Submissions Report

19 Hope Street, Melrose Park, and 69, 71, 73, 75,
77 Hughes Avenue, Ermington

SSD 84348959

Prepared for Hope & Hughes Pty Ltd ATF Hope and
Hughes Unit Trust
Submitted to DPHI
December 2025

Figure 3: Updated Landscape Plan to Eastern Parklands (Source: Sitelimage)

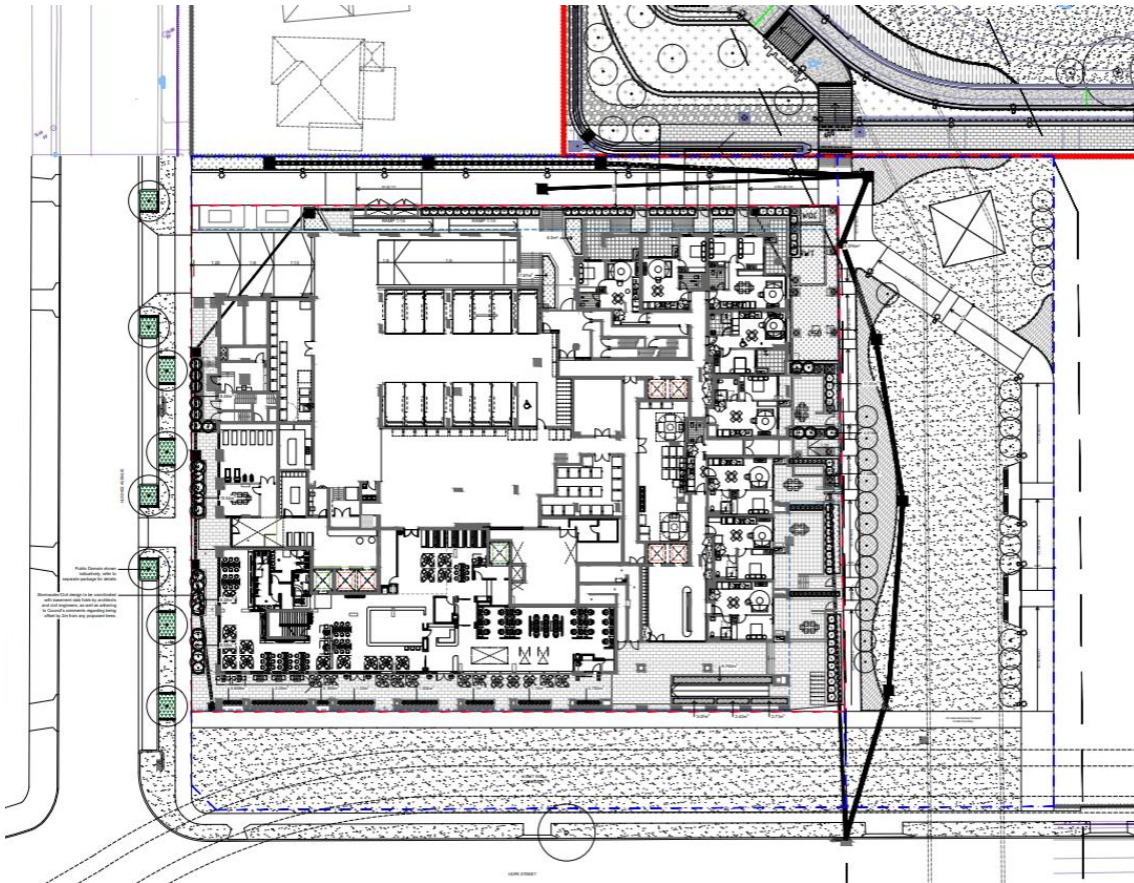
- Ongoing discussions have been held with Council in relation to the detailed design of the proposed parklands. Updated Landscape Plans have been issued to Council for comment (refer to below figure 3).
- The Applicant also sought to arrange a meeting with Council to discuss their submission, and the Applicants proposed response. Unfortunately, Council was unavailable to meet prior to the lodgement of this Submissions Report.

- A revised Subdivision Plan is provided at Appendix 12. This plan has been updated so the proponent can dedicate the 2,561m² parkland to Council in accordance with the executed VPA. Lots 102 and 103 nominated on the plan of subdivision will be transferred to Council. Lot 103 will eventually be resumed by Transport for NSW for PLR2 as was always intended.
